Ref: 740.DA5.320.002

## **RESPONSE TO INFORMATION REQUEST LETTER**

**DEVELOPMENT APPLICATION FOR A MATRIAL CHANGE OF USE – DEVELOPMENT PERMIT FOR EXTRACTIVE INDUSTRY AT THE EXISTING BROMELTON NORTH QUARRY ON LAND SITUATED OFF SANDY CREEK ROAD, BROMELTON, QLD 4285, PROPERLY DESCRIBED AS LOT 1 ON RP98576**

### **OFFICE OF COORDINATOR GENERAL REFERENCE: AP2022/022**

TITLE: Approved vs Proposed Extraction Boundary  
 SCALE: 1:4,000  
 DRAWING NUMBER: 740.DRG.458  
 REVISION: 1  
 DATE: 30 March 2023  
 PRINTED: 31 March 2023  
 CHECKED: MB  
 DATUM: HORIZONTAL / VERTICAL / ZONE  
 MGA / AHD / 56

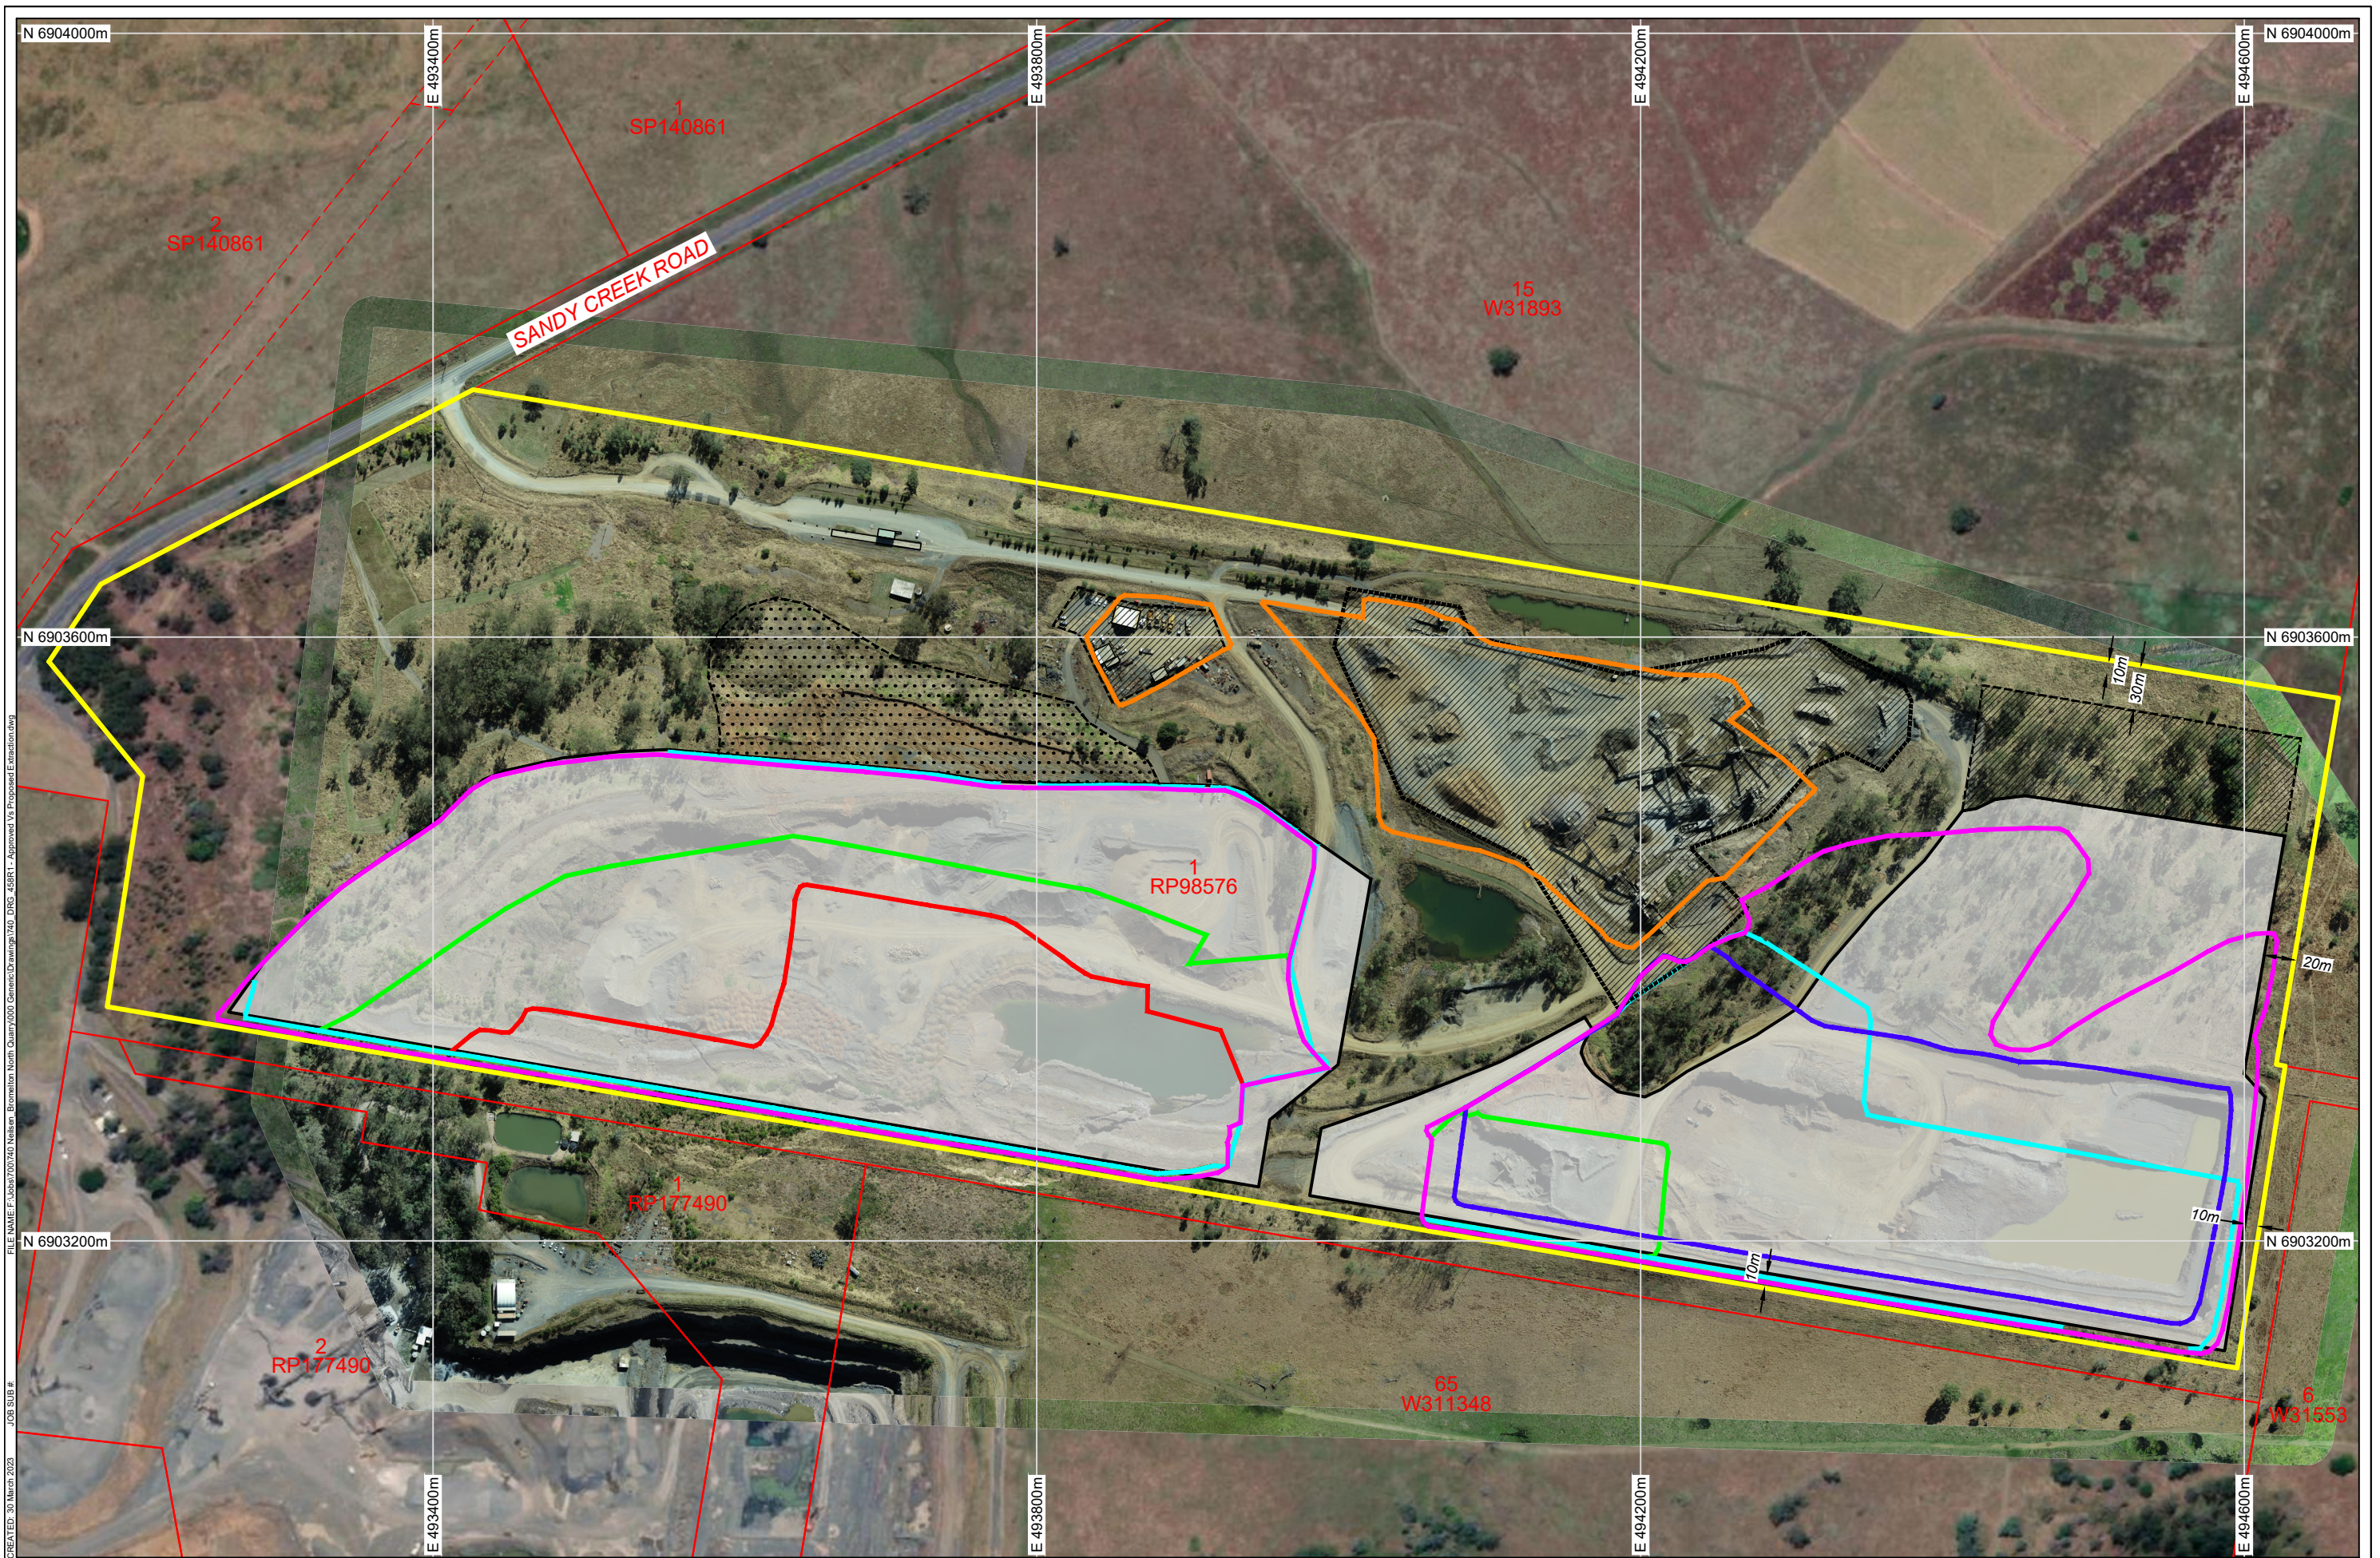
- iii) *weighbridge, workshop and truck wash down facility*
- iv) *security fencing*
- v) *existing and new onsite plant and equipment (if proposed).*
- b) *provide general sequence of extraction for the current operations (including previous extraction) and future extension*
- c) *identify any changes to internal haul routes (if any and as requested above)*
- d) *provide a plan showing current operations (as approved under Consent Order - reference 3448 of 2003) over the whole subject site compared to the proposed operations subject of this SDA application.*

- Approved Plans (Condition ii): A plan has been prepared to visually represent the extent of approved and current operations (refer **Appendix B – Approved and Proposed Development**).

- The West Pit and East Pit have developed generally in accordance with the approved quarry footprint;
- The stockpile and plant area extends beyond the approved area;
- The office/workshop/staff parking area extends beyond the approved area;

As requested by Item 3(1)(a) and 5(1)(d), a plan showing the current approved operation compared to the proposed development has been prepared (refer **Appendix B – Approved and Proposed Development**).

PROJECT: Bromelton North CLIENT: Neilsens Quality Gravels Pty Ltd	TITLE: Site Layout Plan	SCALE: 1:4,000 0 80m DATE: 30 March 2023 PRINTED: 31 March 2023	DRAWING NUMBER: 740.DRG.459 REVISION: 1 DATUM: HORIZONTAL / VERTICAL / ZONE MGA / AHD / 56
--	-------------------------	--	---

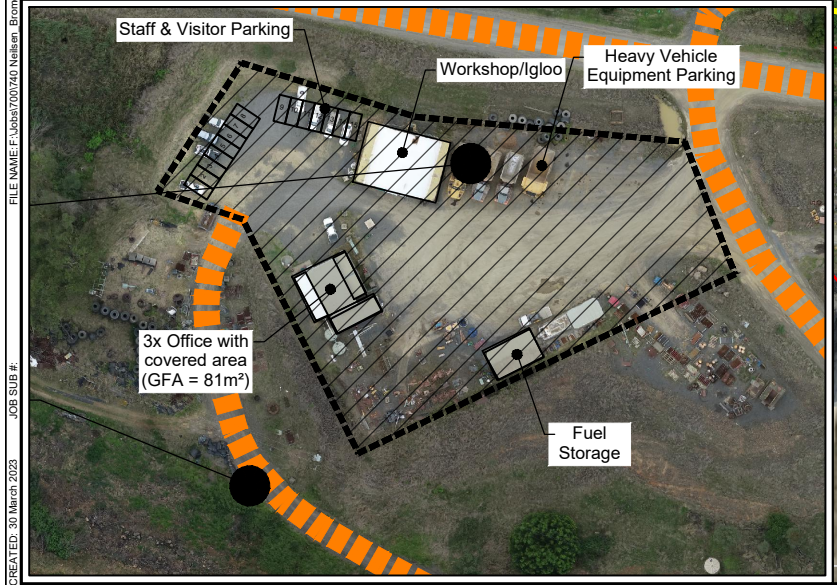
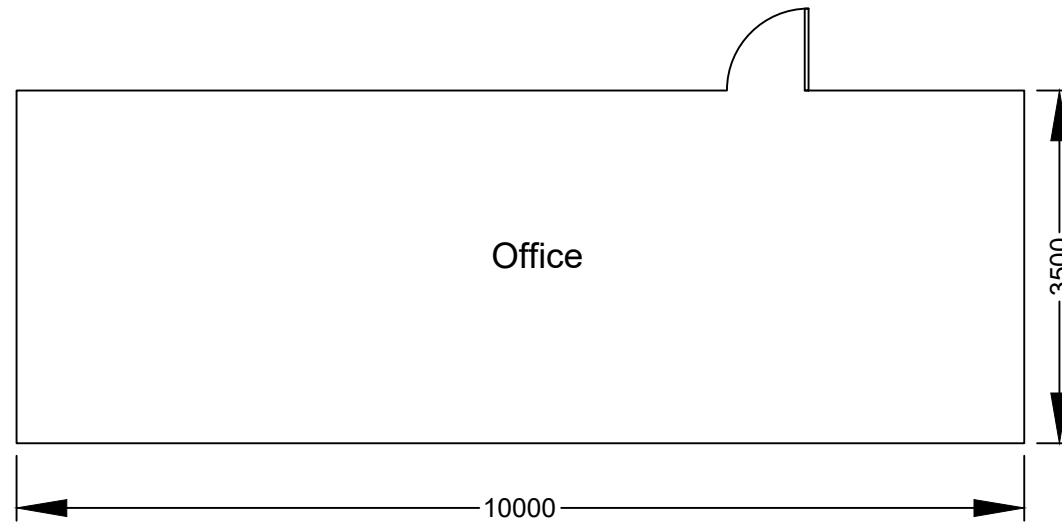
- a) confirm whether the existing internal light vehicle access roads and haul roads are to be retained and/or realigned with the operational changes.

- a) clearly identify facilities and infrastructure that will be retained and/or any new proposed infrastructure including
  - i) site offices and amenities block, truck parking areas
  - ii) car parking for staff and visitors

The site layout plan has been amended to clarify the extent of long-term internal access routes and maintenance tracks (refer **Appendix C – Site Layout Plan**).

An amended site layout plan has been prepared (refer **Appendix C – Site Layout Plan**). As discussed in response to Item 3, there are aspects of the site development which differ from that currently approved. The current extent of operations areas, buildings and infrastructure on site is not intended to change.

The Site Layout Plan identifies:

- location of car parking for staff and visitors;
- location of weighbridge and workshop (in the form of an igloo);
- a 1.5m high barb-wire fence is provided along all boundaries of the site. This has been sufficient to manage unwanted access to the site since commencement of the operation;

- The fixed plant will remain within the central operations area. As detailed in section 3.1 of the Planning Assessment Report, the increased output will be achieved through the efficient use of onsite plant and equipment within the existing hours of operation. The Noise and Air Quality Assessments undertook an assessment of the proposed development, including maximum extraction rate and activities occurring across the site (refer **Attachment 8** and **Attachment 9** of the Planning Assessment Report).

- arrows have been included to demonstrate the sequence of extraction; and
- permanent internal access roads have been clarified. As mentioned above in response to Item 4, vehicle routes within the pit are subject to change during the course of extraction activities and are therefore not shown on the site layout plan.

A vegetation buffer is proposed along the northern boundary, as shown on the site layout plan (refer **Appendix C – Site Layout Plan**). The purpose of this vegetation buffer is to minimise and soften the visual appearance of the proposed development from surrounding properties and vehicles travelling on Sandy Creek Road.

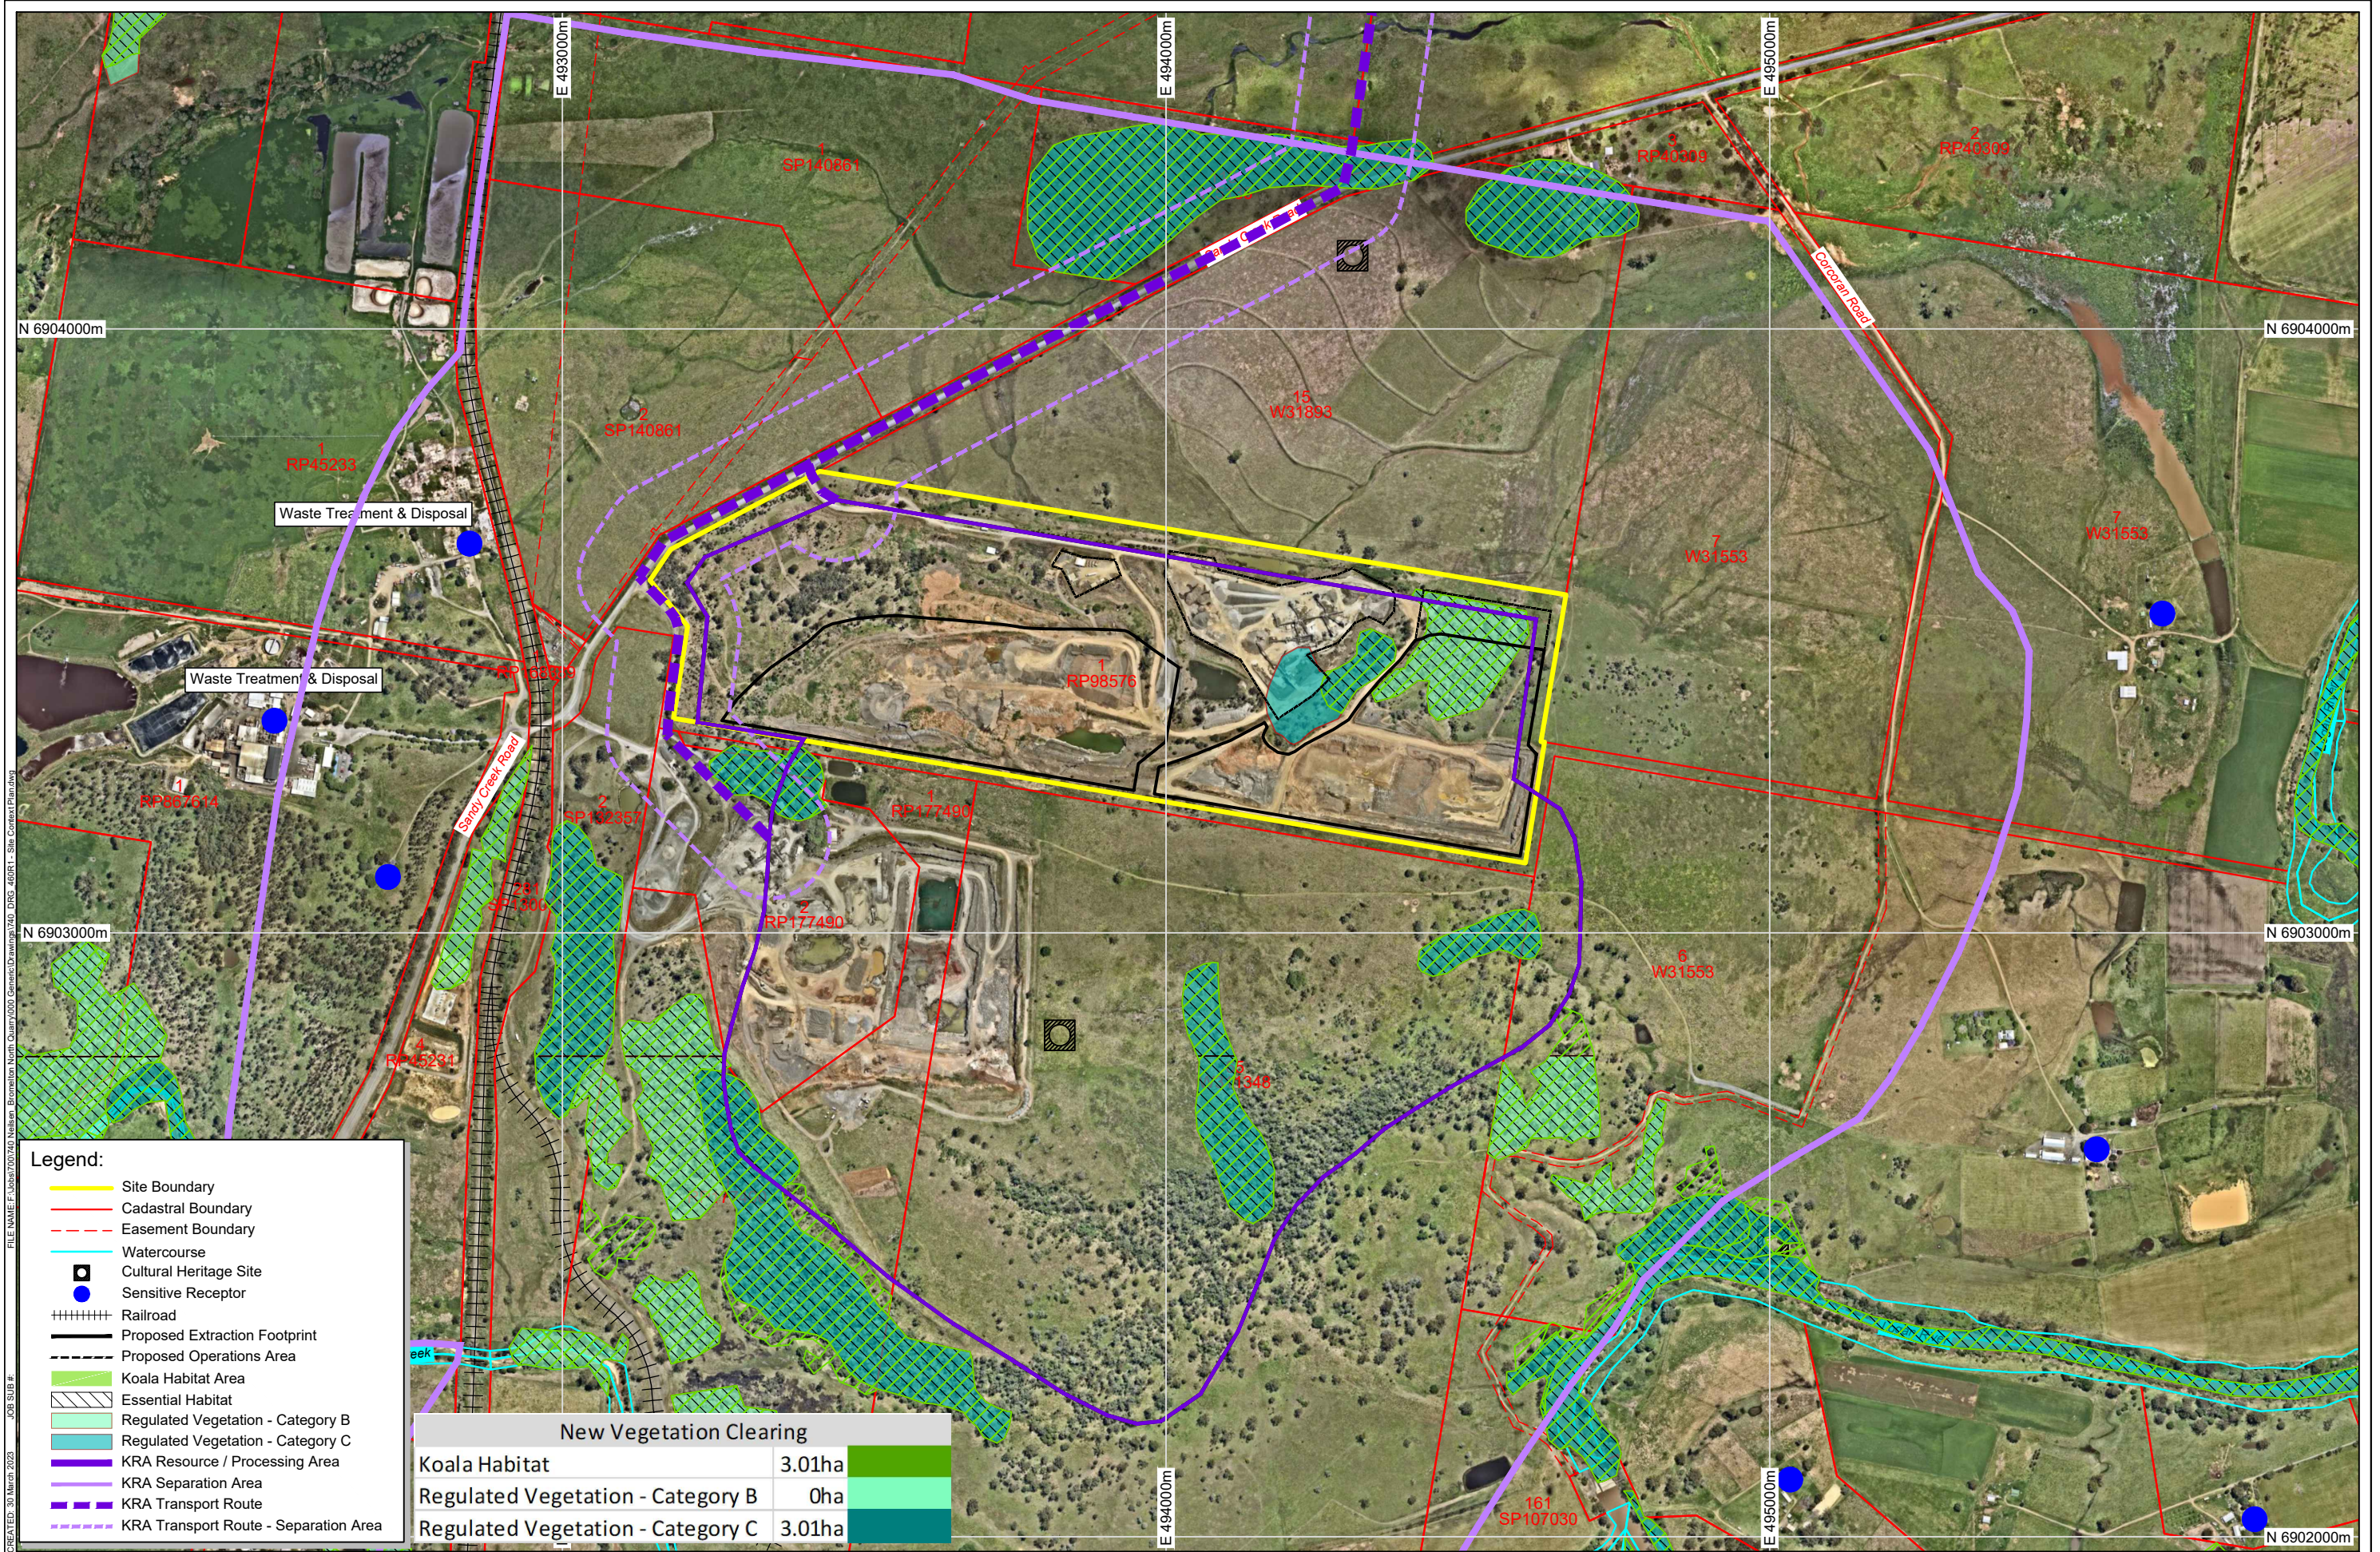
- a) *identify any relevant environmental values, cultural heritage values and community values both on the subject site and in the immediate surrounds;*
- b) *identify any mitigation or management strategies that will be implemented to protect these identified values from adverse impacts.*

A new plan has been prepared which comprises relevant environmental, cultural heritage and community values located in both the Bromelton North Quarry and the immediate surrounding area (refer **Appendix E – Site Context Plan**).

The applicable values include: Remnant Vegetation (remnant and regrowth), Core Koala Habitat, Key Resource Area, sensitive receptors, the adjacent quarry site boundary, other adjacent uses, surrounding creeks/rivers and registered cultural heritage sites.

Reference is made to the plan prepared in response to Item 7 (refer **Appendix D – Site Context Plan**). This plan shows the extent of mapped remnant (Category B) and regrowth (Category C) vegetation on the site.

Reference is made to the plan prepared in response to Item 7 (refer **Appendix D – Site Context Plan**). This plan shows the extent of mapped Core Koala Habitat on the site. The proposed development intersects with 3.01 hectares of Core Koala Habitat, all of which is proposed to be cleared.
